South Coast Air Quality Management District

Draft Environmental Impact Report (Draft EIR) for the Biogas Renewable Generation Project (Proposed Project) (SCH No.: 2017081062)

ATTACHMENT A**South Coast AQMD Staff's Detailed Comments on the Draft EIR****South Coast AQMD Staff's Summary of Project Description in the Draft EIR**

Figure 1 – Process Flow Chart*

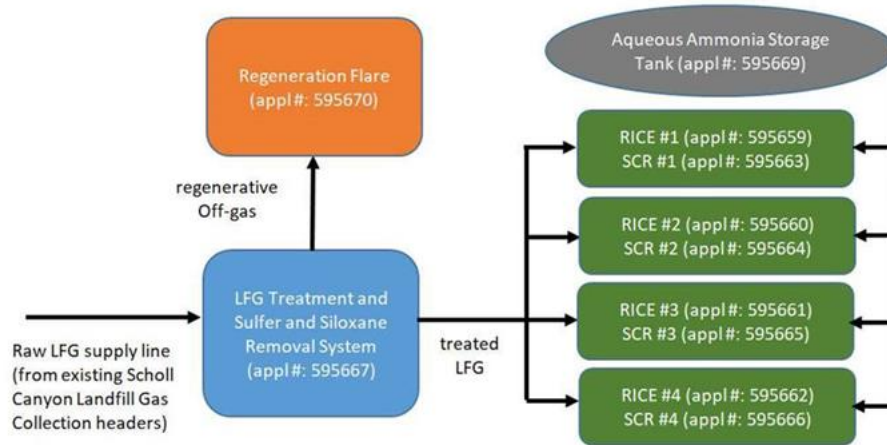
As shown in Table 1, South Coast AQMD received the permit application (A/N: 595670) for the regenerative gas flare. The Lead Agency identified the need for the regenerative gas flare to incinerate off-gases from the LFG sulfur and siloxane removal system in the MND¹⁰, submitted this permit application in 2017, and provided South Coast AQMD staff information about this flare¹¹. At the time of the release of the Draft EIR, the Lead Agency did not withdraw or make any changes to the permit application (A/N: 595670). Therefore, the regenerative gas flare is a component of the Proposed Project.

The regenerative gas flare is a landfill and digester gas fired flare. As illustrated in Figure 1, the Proposed Project would include an LFG treatment system that uses carbon absorbers that are periodically regenerated and vented to the new regenerative gas flare. According to the South Coast AQMD permit application (A/N: 595670), flaring of regenerative off-gases will take place eight hours a day, four days a week, and 52 weeks a year.

Although the Draft EIR discusses the use of a ground flare to dispose the regeneration gas, the Lead Agency did not fully describe the regenerative gas flare in the Project Description or analyze the associated air quality and health risk impacts in the Draft EIR. Regenerative off-gases will be generated from implementation of the Proposed Project's LFG treatment system and are not currently being flared. The regenerative gas flare is also different from the exiting

LFG flares because the LFG treatment system that produces regenerative off-gases is undertaken and completed prior to combusting the LFG in the reciprocating engine generators. Therefore, the regenerative gas flare should not be treated as part of the existing conditions and its air quality and health risk impacts should be adequately analyzed and fully disclosed in the Final EIR before the permit for this flare can be issued.

Figure 2 – Illustration of Facility Boundary in Air Dispersion Model

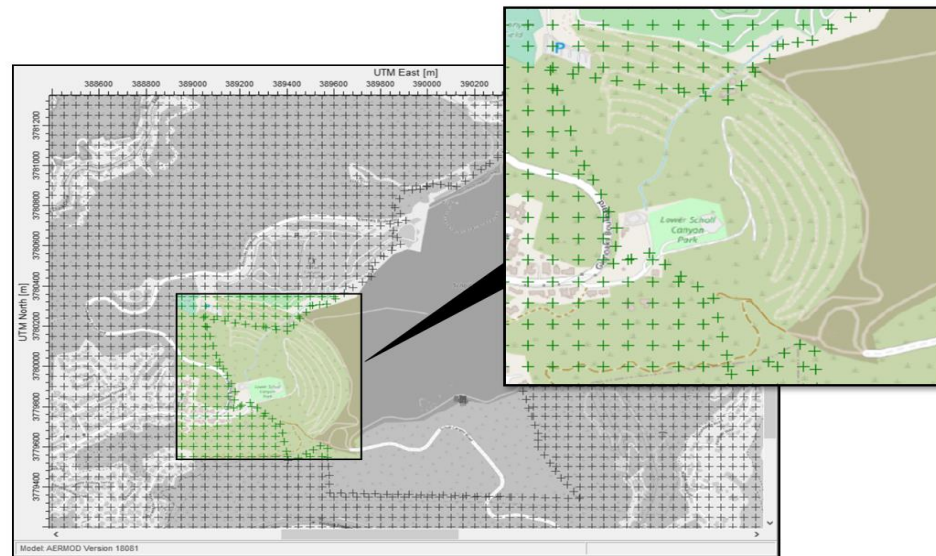
- b) As illustrated in Figure 2, the facility boundary used in the air dispersion model includes an area for the Lower Scholl Canyon Park (Park). As such, no sensitive receptors (denoted by the green “+” symbols) were placed within the Park boundary. This is not appropriate. The Park has three picnic structures, two playgrounds, and a public parking lot¹⁵. Because the general public has access to the Park, receptors should have been placed within the Park as it is considered to be ambient air. As such, South Coast AQMD staff recommends that the Lead Agency revise the facility boundary in the air dispersion modeling to exclude the area for the Lower Scholl Canyon Park from the facility boundary.
